RE: **Avery & Birch – Preliminary Approval**
21055 Crossroads Circle BKFT1129999007

Application Type: Preliminary approval of a new building consisting of a three-story salon suite facility

CONSTRUCTION PLANS
FOR
AVERY & BIRCH
21055 CROSSROADS CIRCLE
TOWN OF BROOKFIELD, WISCONSIN

Strand Associates, Inc.[®] (Strand) has finished its initial review of the plan package for the Avery and Birch Development that was received from the Town on December 28, 2023, for conformance with the Town specifications and general engineering practices. Before construction may begin, the contractor shall submit all required permits for the development to the state, Wisconsin Department of Natural Resources, Town, and any other relevant agencies. New drawings and a letter describing the revisions should be returned to Strand after the following concerns have been addressed.

SITE LANDSCAPING

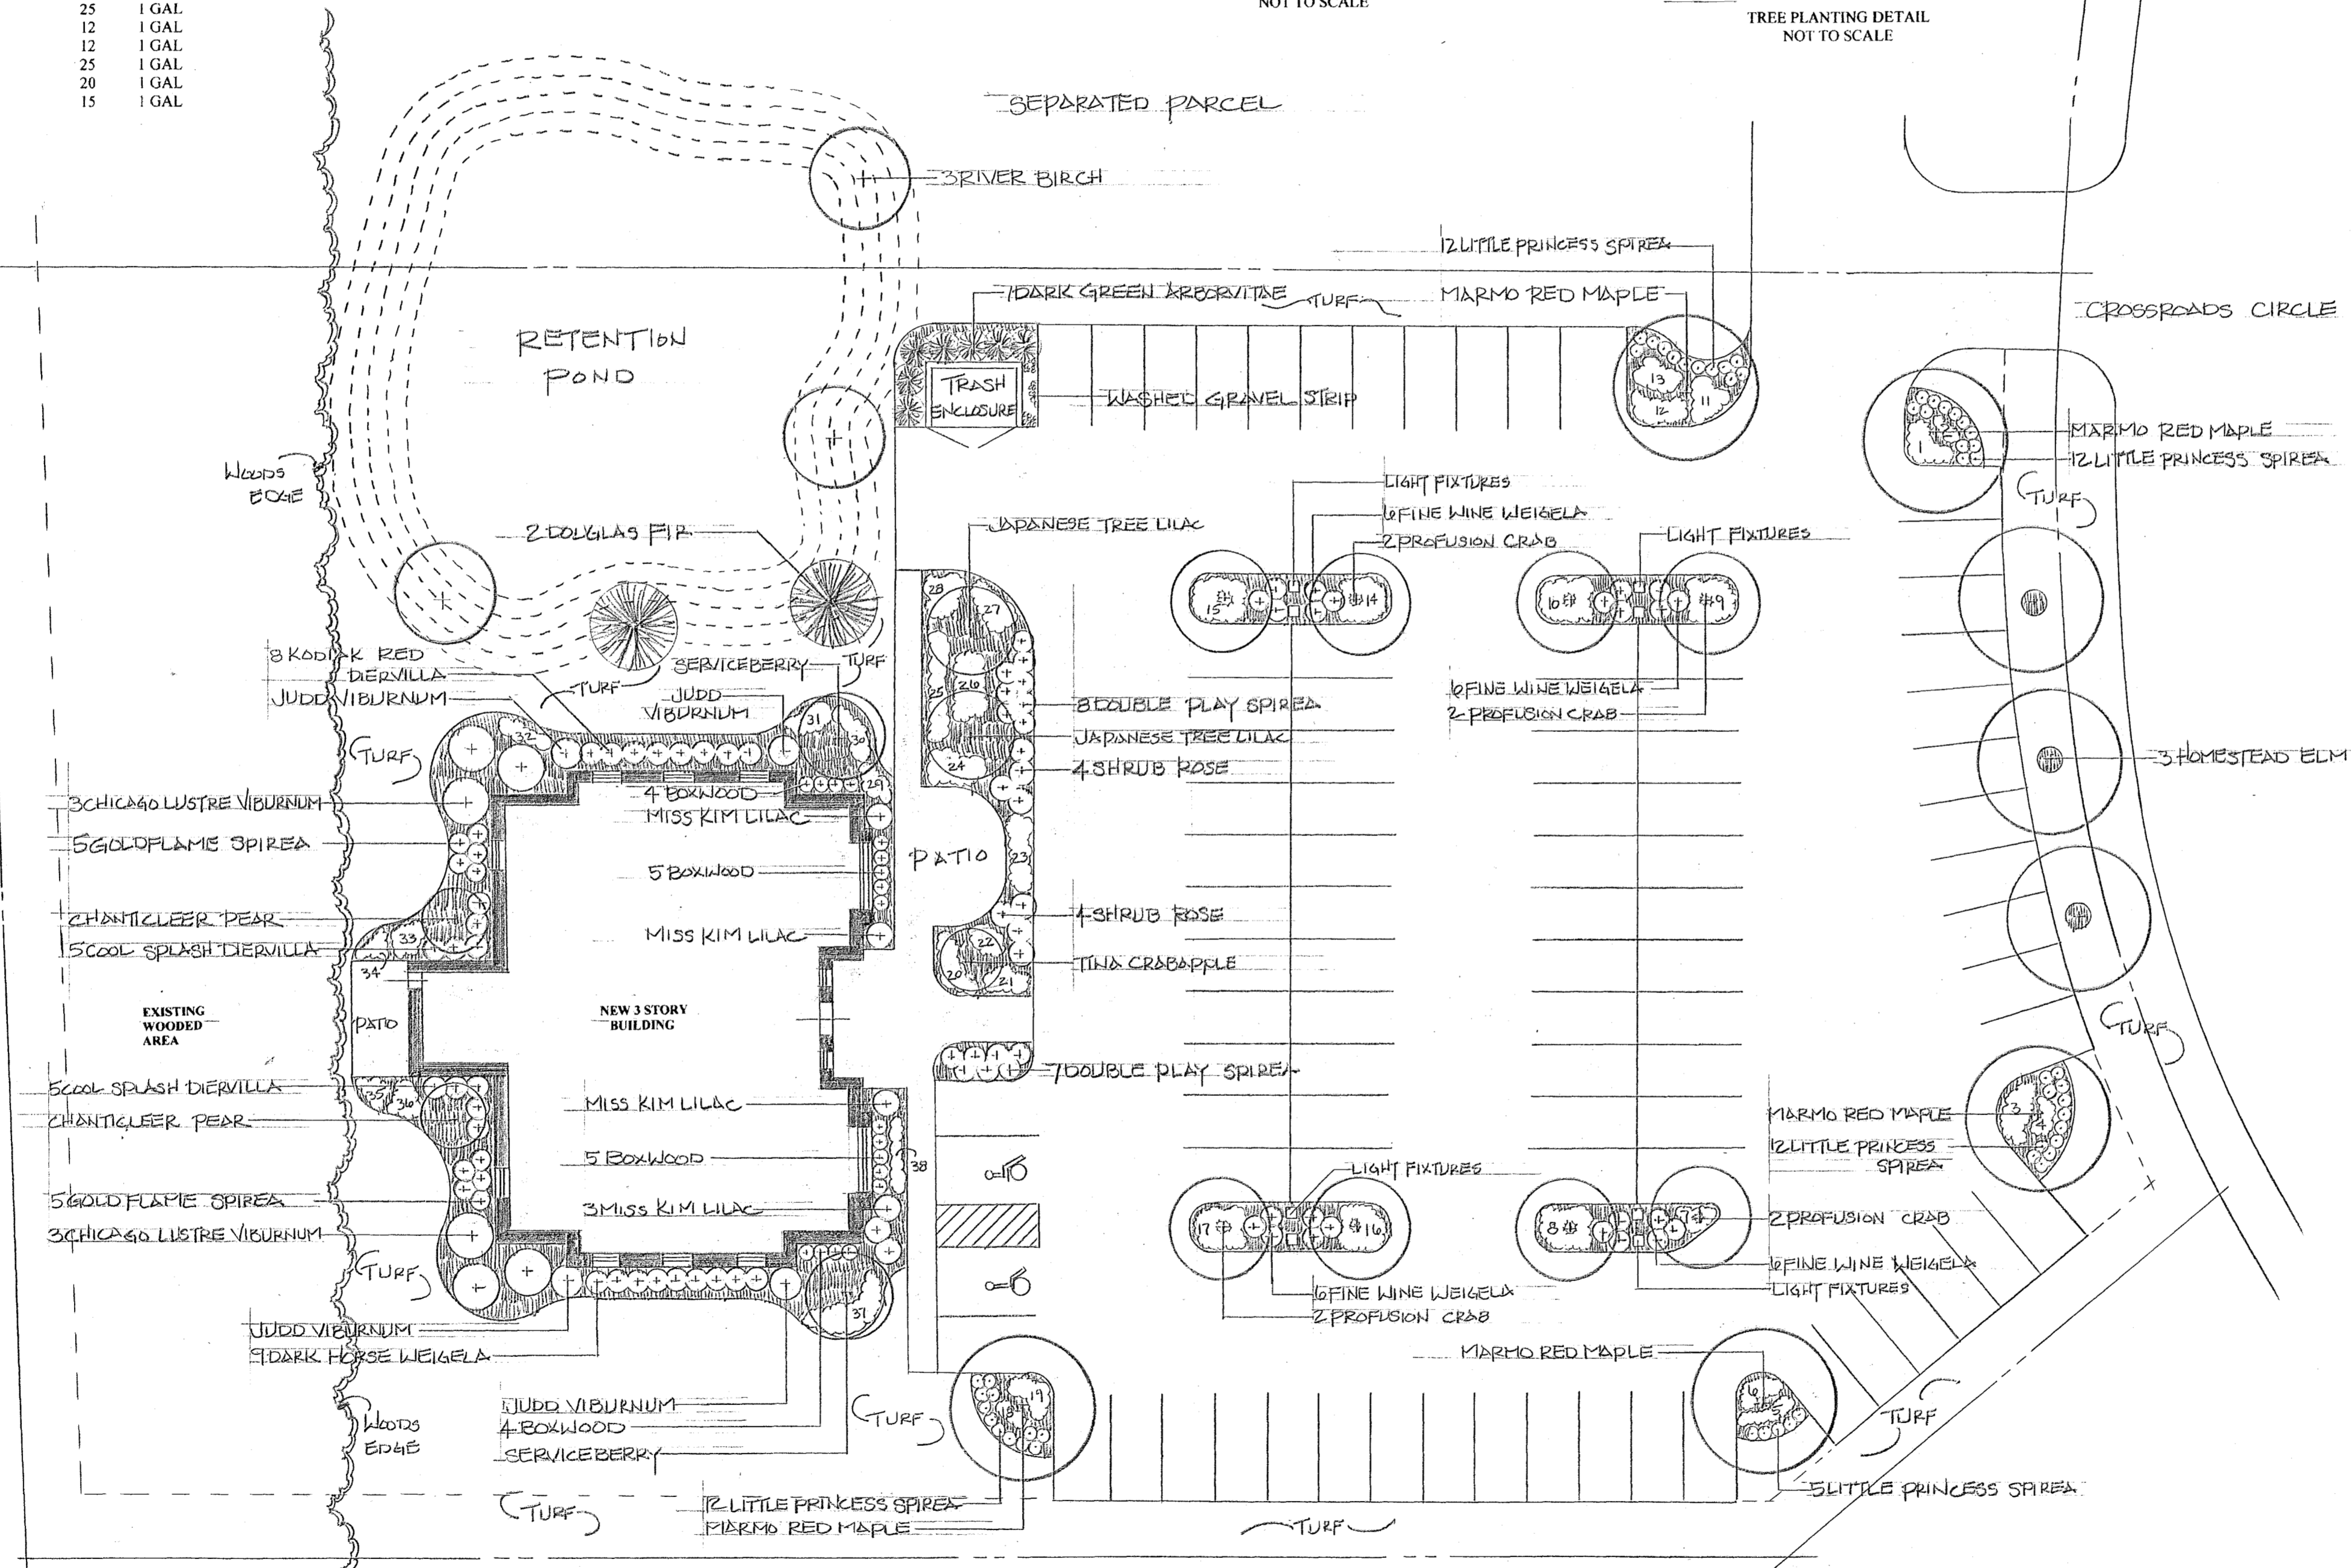
1. It should be verified that the mature spread of the trees, specifically the Homestead Elm trees, will not extend beyond the lot line (Section 17.02.19.e.).
2. Please show trees for preservation on future drawings. Also, in accordance with Section 17.02 (6) 19.C, provide information on natural forest or woodland areas and substantiality or quality thereof.

ES01

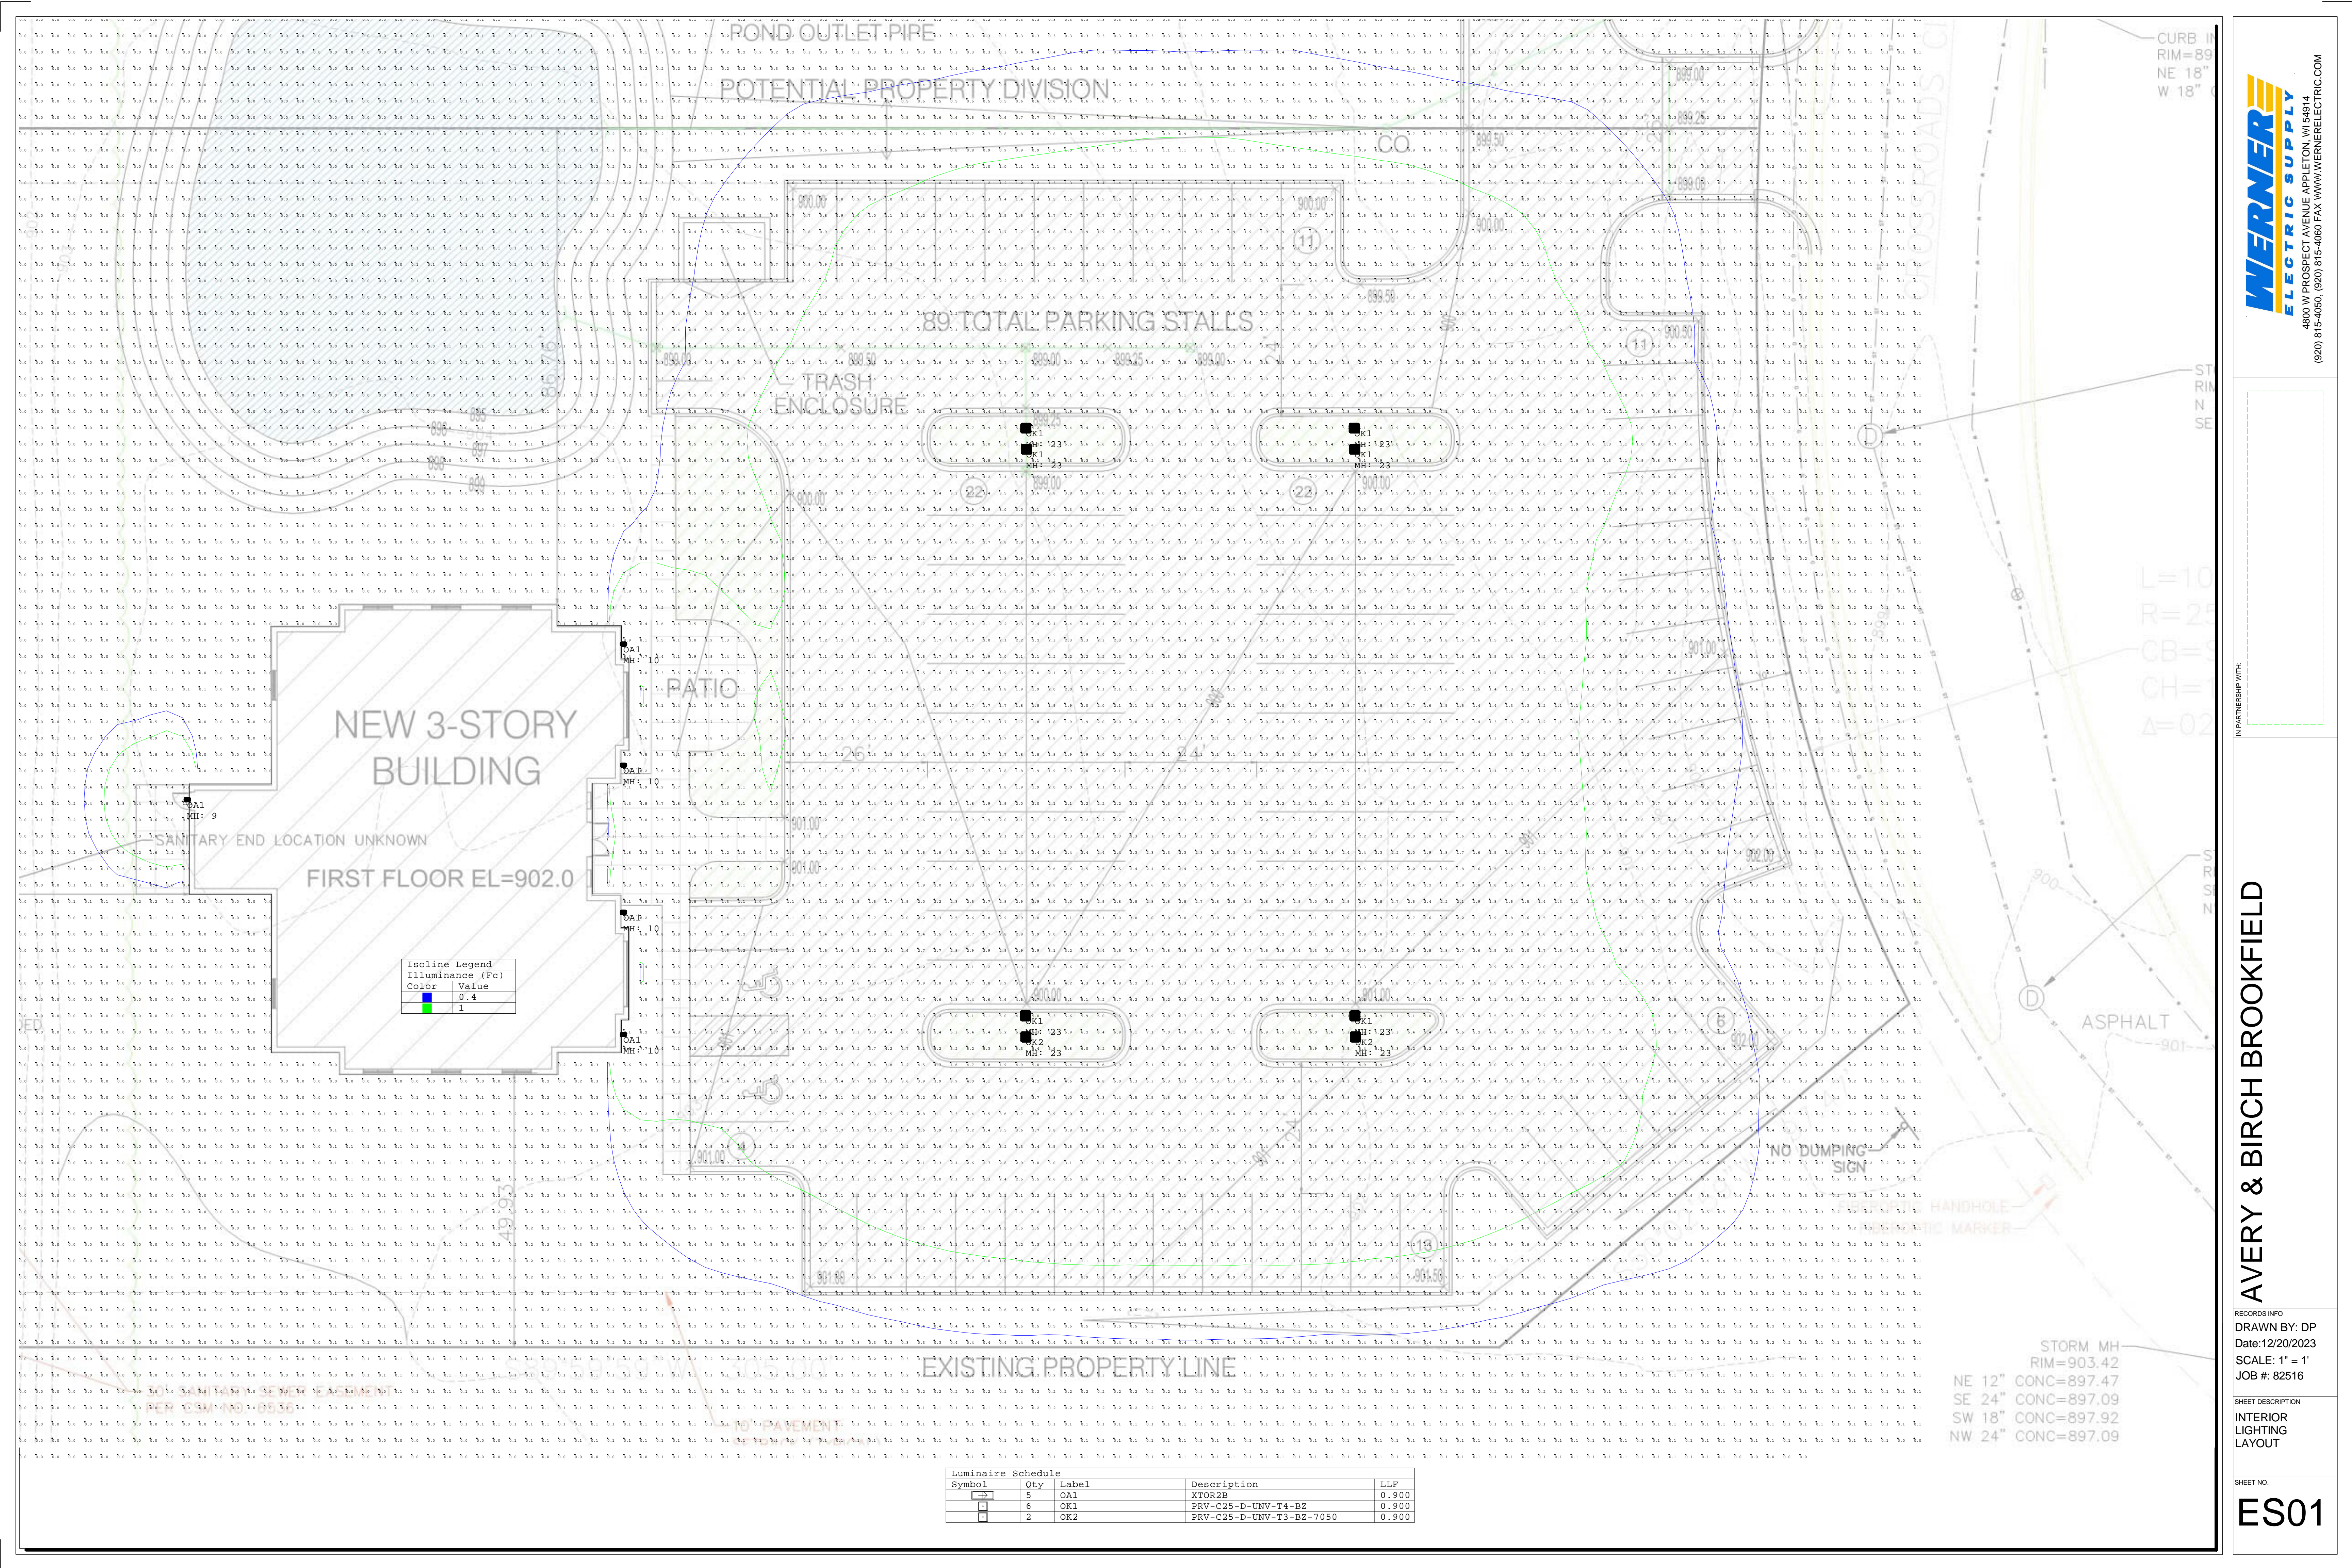
1. It appears that the intensity of illumination measured at the property line exceeds 0.2 foot-candles at numerous locations (Section 17.02(6)(15)d.).
2. All areas designated on approved site plans for vehicular parking, loading, or circulation and used for any such purpose after sunset shall provide artificial illumination in such areas at a minimum intensity of 0.4 foot-candle, exclusive of approved anti-vandal lighting (Section 17.02(6)(15)c.).
